**Southern
Water**

Your ref
BN/112/20/EIS

Proposal: Environmental scoping opinion for up to 1500 dwellings, community facilities, local centre (shops and services), a primary school and associated playing fields and early years provision (nursery).

Site: BN/112/20/EIS: - Land at Barnham, Eastergate and Westergate, PO22 0ED.

Printed By: kishoku

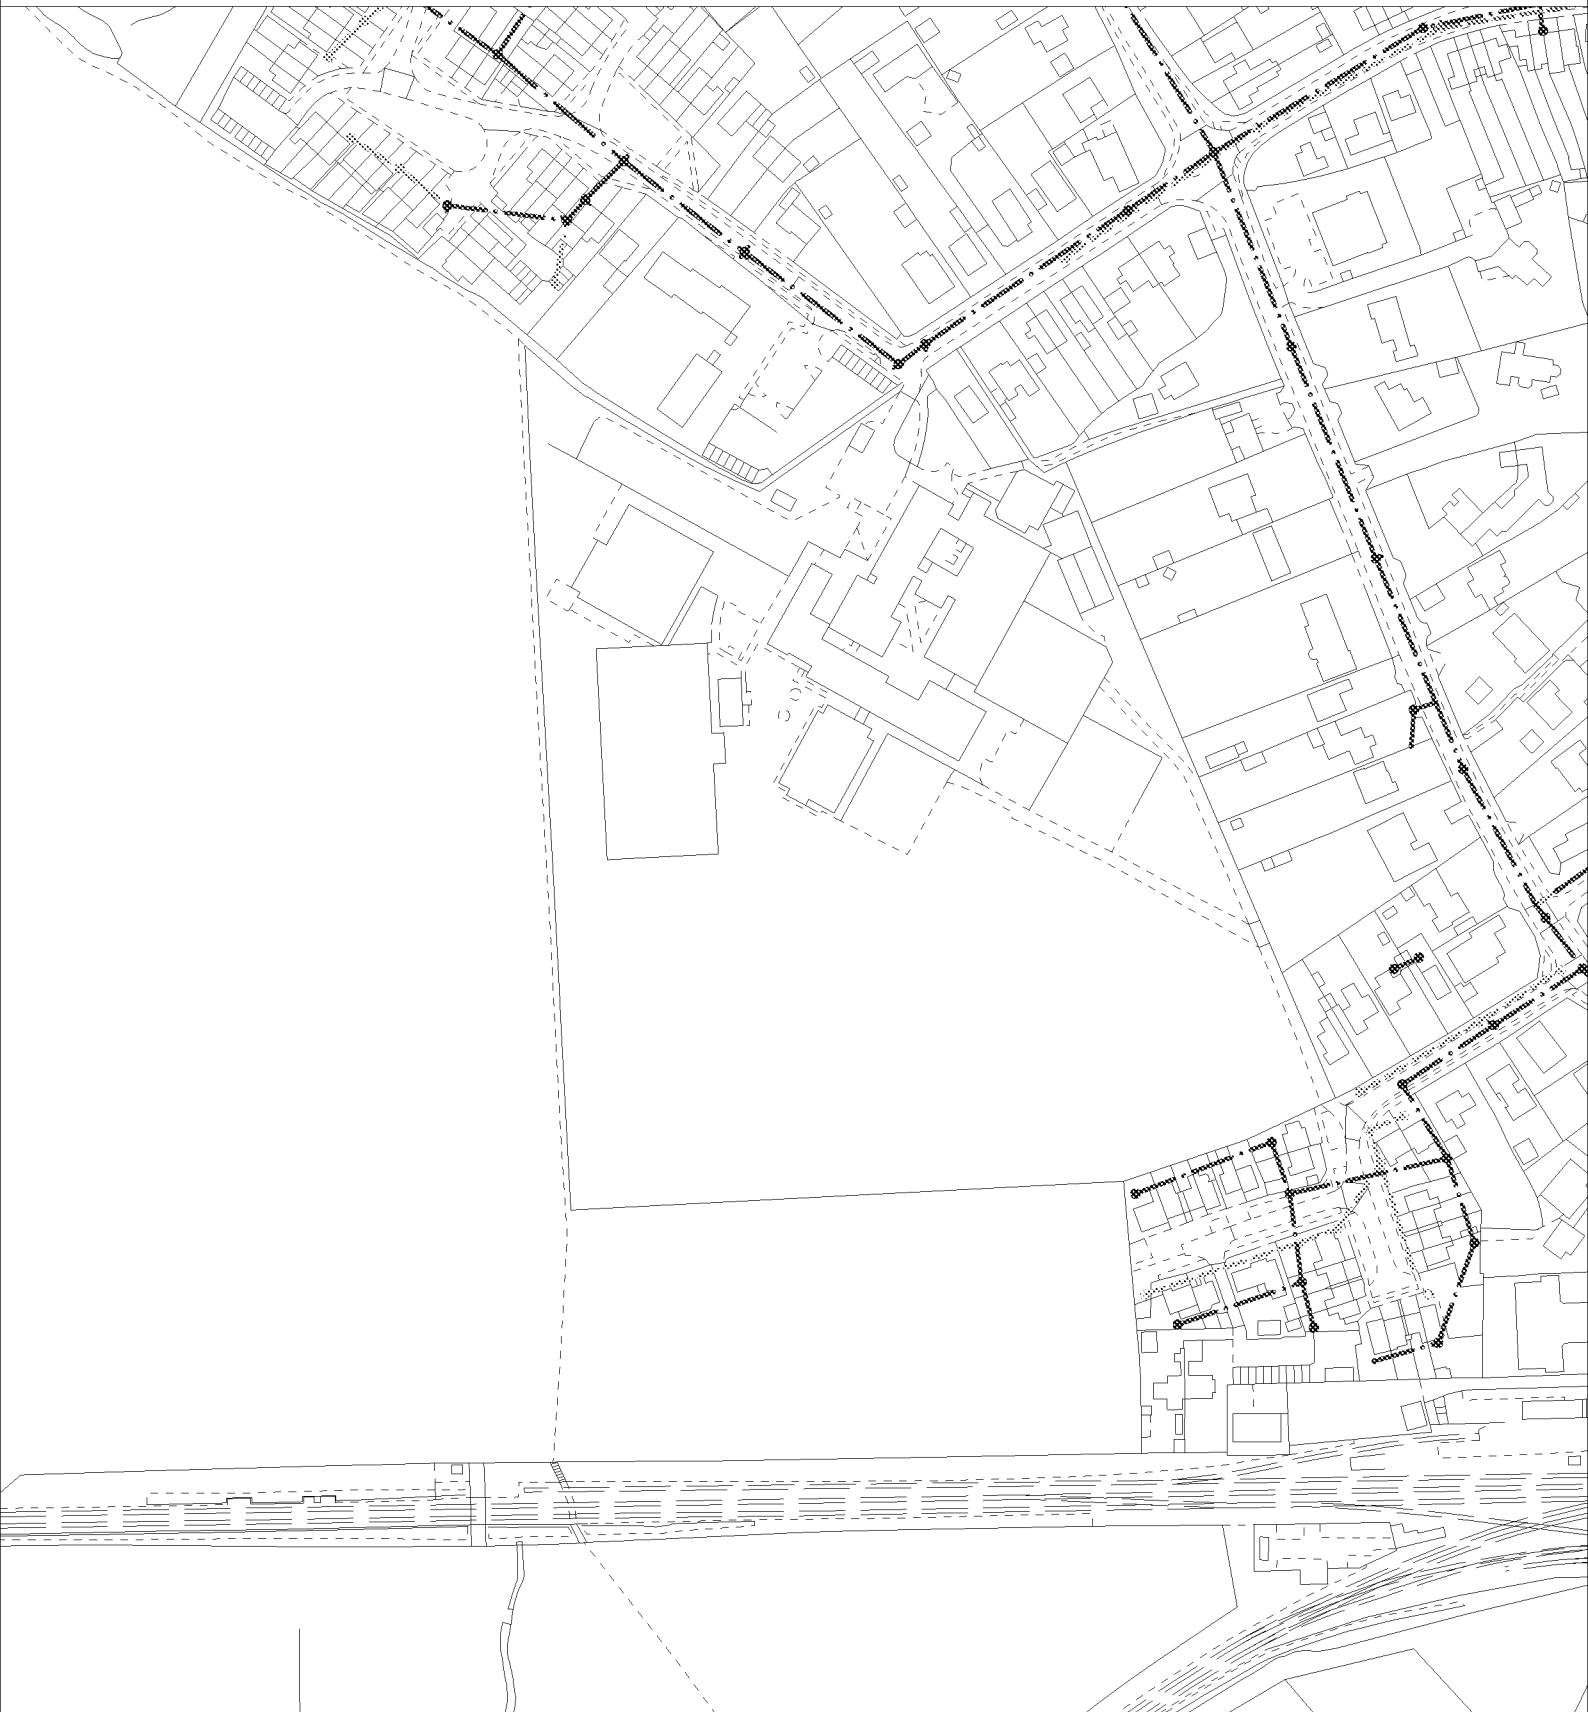
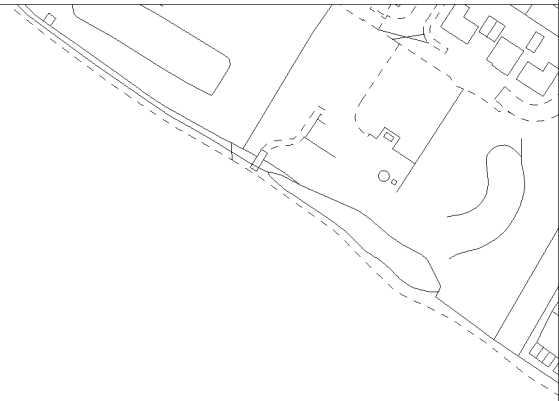
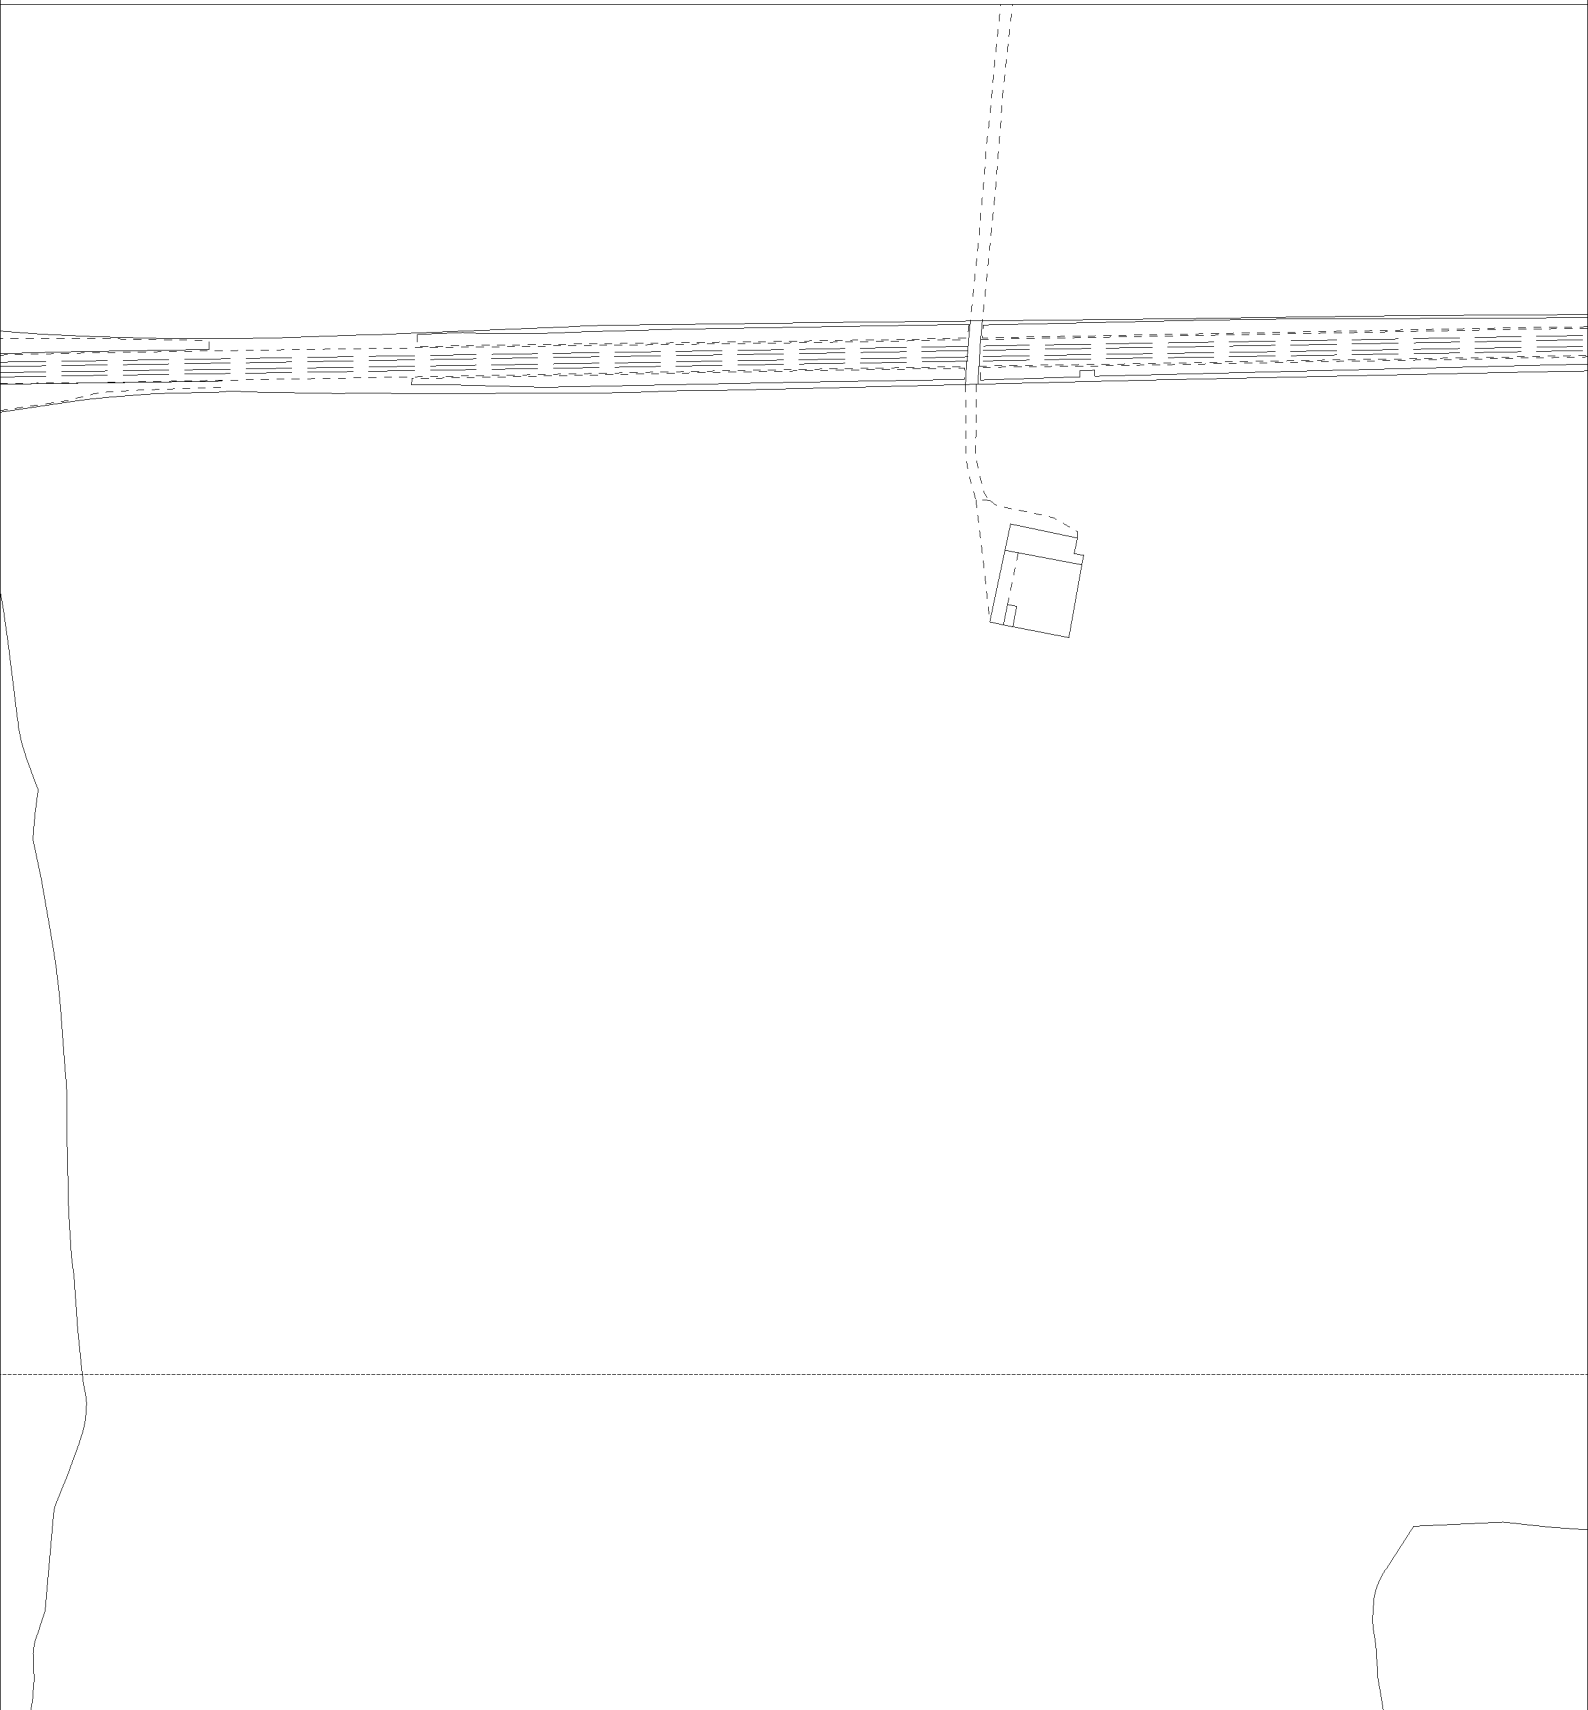
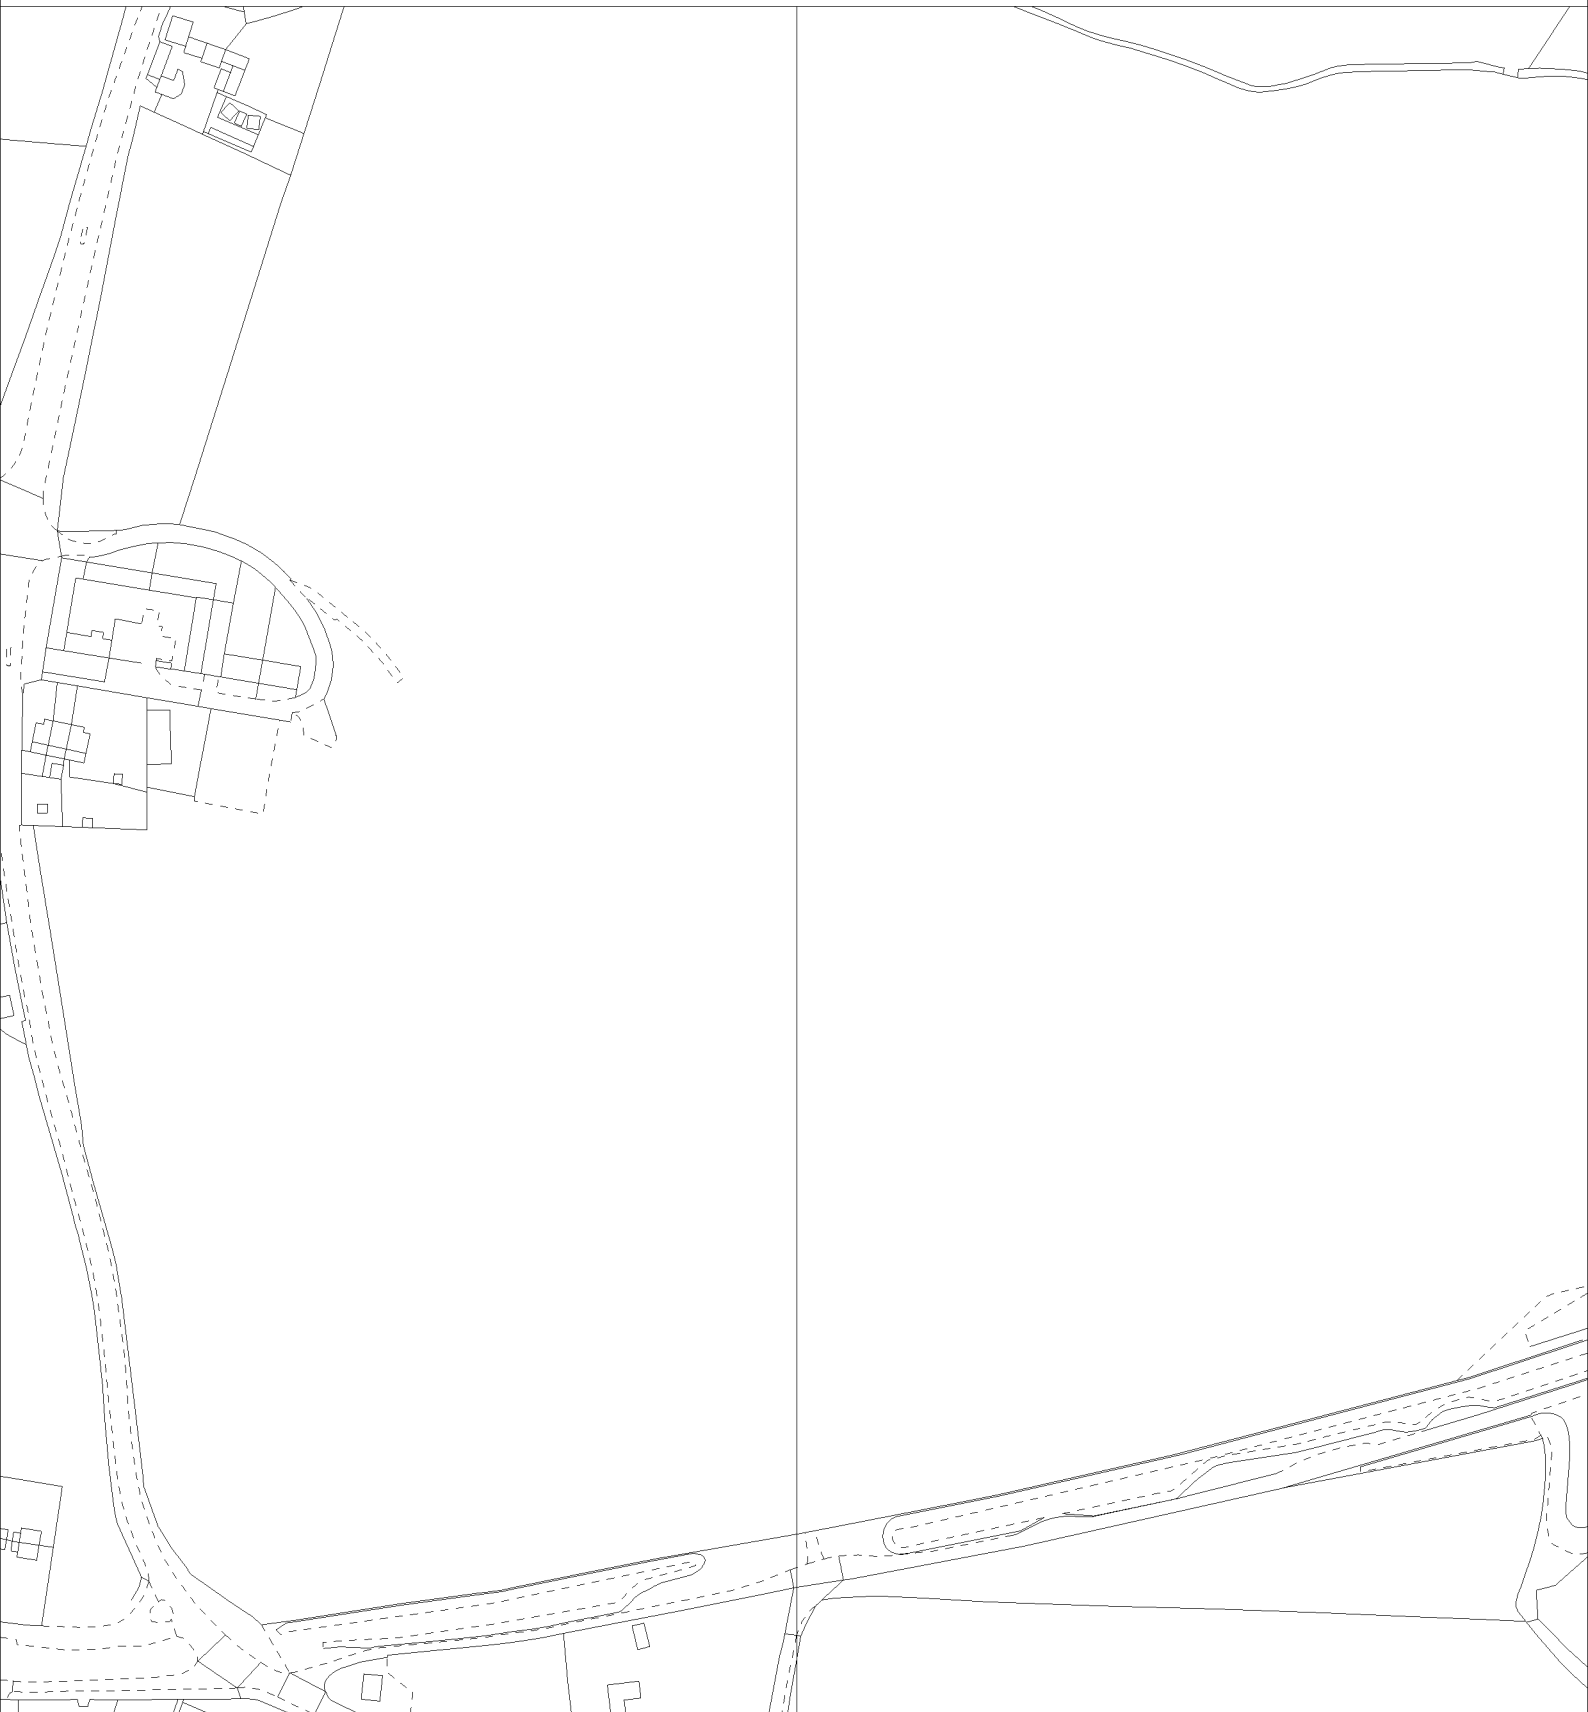
- Southern Water's current sewerage records show that there are foul sewers within the proposed development site/s. No new development/building works will be permitted to be constructed over or within 3.0 metres of the existing foul sewers. Sewer record attached for your information.
